Project number	1002100	Meeting date	2022-09-30
Project name	Mogalakwena solar PV plant	Recorded by	ZPX
Meeting/subject	Mogalakwena PV Plant Meeting	Total pages	5

Item	Topic
1	Purpose of the Meeting
	The virtual meeting was coordinated by the Environmental Assessment Practitioner (EAP) and the applicant to present the updated Basic Assessment Footprint to the competent authority, LEDET, and to correct the footprint that was erroneously included in the new application for a Basic Assessment.
2	Introduction

Figure 1: The revised footprint of the BAR application.

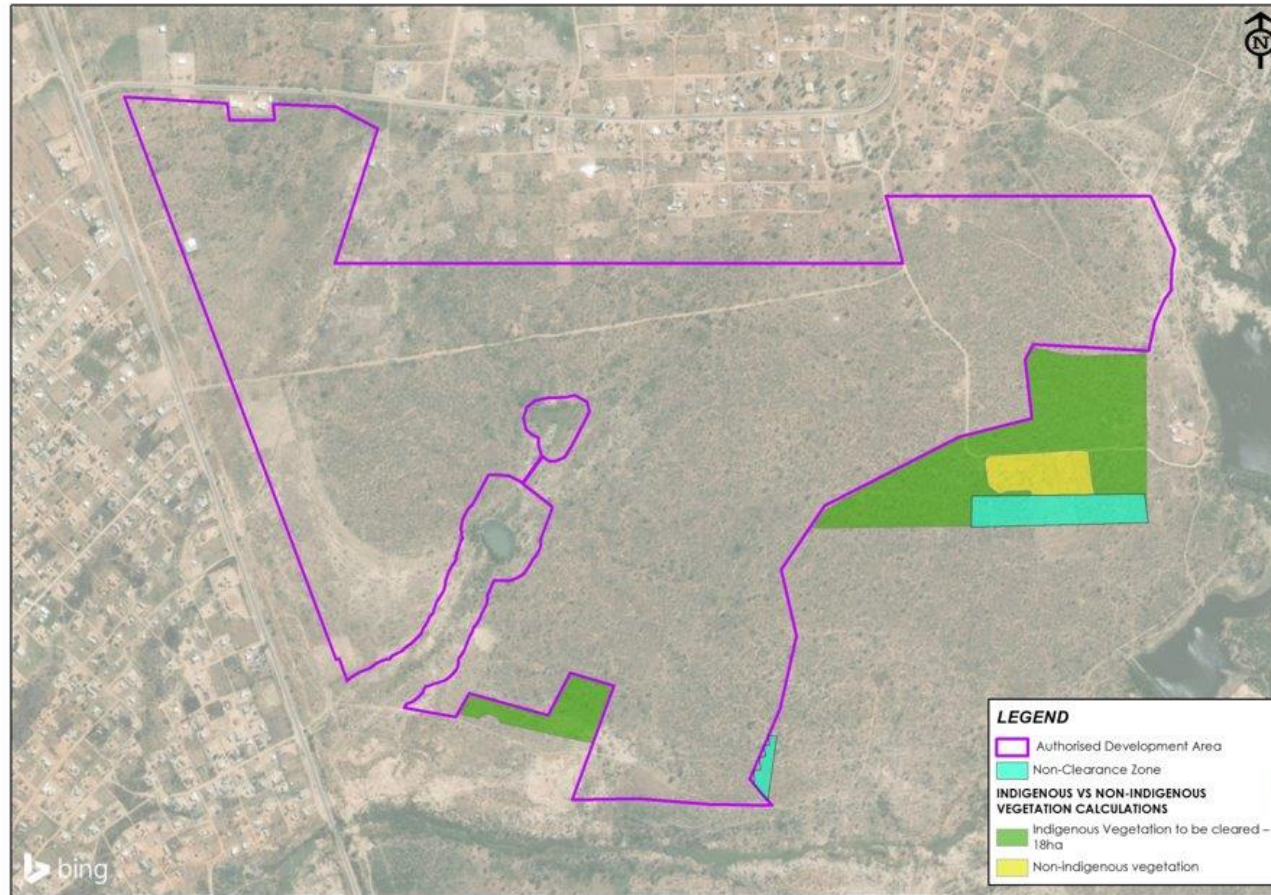
Item	Topic
	During the virtual meeting, Mr Reuben Heydenrych explained the need to proceed with a new application for Environmental Authorisation (EA) (Basic Assessment). He highlighted the following key issues: Area of Expansion • After the submission of the basic assessment application to LEDET, Mr Ngoasheng had concerns about the BA vs Scoping/EIA triggers. • It was highlighted that LN2 (Scoping/EIA) will be triggered if an application of clearance of more than 20ha of indigenous vegetation was done. • The submitted application was for approximately 16ha of the Critical Biodiversity Area (CBA); but the total footprint that was in the application was in fact 32ha which triggers an activity in LN2, should more than 20ha of indigenous vegetation be required to be cleared. • The CBA and adjacent area include only 17.8ha of indigenous vegetation. • The submitted application ended up with 32ha because the development layout for the BAR application included an incorrect buffer around the drainage line. However, the area applied for in the Scoping and EIR application included everything up to the 32m watercourse buffer. The developers utilised a 100m buffer erroneously, which lead to an increase in footprint size. • The mistake in footprint extent was mainly due to the engineering layout being based on incorrect spatial data. • Mr Heydenrych explained that the existing EA approves a 32m buffer around the drainage line. It is important to note that the 32m buffer is not specifically stated in the existing EA, however, the footprint that was included in the EIR, the coordinates and the mapped area include everything up to the 32m buffer. The specialist reports recommend a 32m buffer. Indigenous Vegetation and Degraded Land in the CBA • Within the CBA, there is cleared crop land that is 2.53ha (see Figure 2) and does not constitute as indigenous vegetation as per the definition in the EIA regulations and the vegetation specialist, and therefore can be excluded from the application. • The specialists have also confirmed that the area is not considered indigenous vegetation because it has been altered and cleared for agriculture. Google satellite imagery supports this (see Figure 2). Areas that PGE wants to apply for • The total indigenous vegetation to be cleared for expansion area totals 18ha (see green area on Figure 1).

Item	Topic
	Indigenous Vegetation and Degraded Land in the CBA <u>Response from Mr Chuene</u> • Mr Chuene indicated that he did a time series check to determine the state of the degraded land portion in the previous years and to check when it started to deteriorate. His results show that degradation took place somewhere around 2020, because before that year the area seemed to be okay. • He advised that one should be careful when classifying this area as a non-natural area because the area is wedged between fairly intact, although not so good, vegetation. The assumption is that the degraded land is a result of an illegal activity which was not authorised by LEDET, therefore it makes it difficult to classify the vegetation of the degraded land as non-indigenous with confidence. • It is also important to note that the degraded land has a potential for recovery, and it will be wrong for LEDET to propose that it can be zoned as non-indigenous. Mr Chuene is adamant that there is a potential for the degraded land portion to recover and that in fact, it looks like it has started recovering. • Mr Chuene further indicated that when they account for the total footprint of the vegetation type, the degraded footprint is included because there was never an application to conduct the activity that led to the land being degraded. He stated that this will put them in a very compromising situation should they accept that the degraded footprint is now classified as non-indigenous because of the illegal activities that took place on that footprint. This will be as good as using the legitimate process that the applicant is planning to undertake to conceal an illegitimate conduct that had occurred on that portion of land. • He advised that the footprint highlighted as non-indigenous should be included in the application as part of the total indigenous vegetation to be cleared for expansion area to simplify things. • In addition, it is important to note that with vegetation, LEDET does not only looking at what's on the ground, but they also look at the seedbank when considering issues of recovery. The activity on the degraded land is recent, and it might recover when left undisturbed. • The fact that the vegetation does not look good and that there is a lot of encroachment simply means that there are poor land management practices in the area but that does not negate the fact that the area is suitable for the indigenous vegetation type. • Lastly, the applicant should not use the issue of the degraded land parcel to their advantage of not pursuing the alternative authorisation process, which is a part 2 amendment process or a scoping and EIR process. <u>Response from Mr Ngoasheng</u> • Mr Ngoasheng advised that The Department of Water and Sanitation be consulted to verify the buffers that are used as the basis of the project footprint. • He further explained that the definition of indigenous vegetation explicitly states that the disturbance should be lawful or done as a result of an authorised activity, therefore, the EAP and the applicant should take that into consideration when concluding that the degraded footprint is non-indigenous. • Mr Ngoasheng also explained that LEDET is under the impression that the EAP and the applicant are trying to avoid applying for the scoping and EIR process because it's perceived as a longer process. He notes that they have noted the reasons why the EAP does not want to take the amendment route, and he emphasised that whichever route the EAP and the applicant take, they should ensure that it is an honest assessment of the situation and that they should comply to avoid any hiccups on the way. However, they should bear in mind that their application will be processed and judged against the believe that they don't want to do scoping and EIR because of the longer period that it might take to process the application.

Item	Topic
	Indigenous Vegetation and Degraded Land in the CBA - Mr Heydenrych indicated that this is the status quo of the land as it is right now, and that the application should be based on the current status quo. He further highlighted that based on the definition of what constitutes as indigenous vegetation, the portion of vegetation on the CBA does not classify as indigenous vegetation. - The condition of the vegetation in this area is not good and it is heavily grazed. There are settlements on the north and west side of the footprint and there are dense areas used for residential development so there is a lot of pressure on the area. Given the fact that the mine is there and that the residential areas are expanding, the potential for the area to recover properly is limited. - Furthermore, the applicant shouldn't be held responsible for the state of the degraded land the suspected illegal activities that might have taken place. - Mr Khumalo proposed that a professional opinion letter from a specialist stating that the degraded land parcel must be classified as non-indigenous should be provided to LEDET for reference.

5	Way forward
	- Zutari to provide determination of buffers by specialist as requested in the existing EA together with the General Authorisation clearly indicating the buffers that were used. - Zutari to provide a professional opinion letter from a specialist to indicate that the degraded portion on the CBA does not constitute indigenous vegetation and careful attention should be paid to the definition of indigenous vegetation on the NEMA regulations. - Mr Cheune advised that the applicant should suggest rectification measures for the degraded land parcel in the CBA.
6	Closing
	Zutari to provide draft meeting minutes
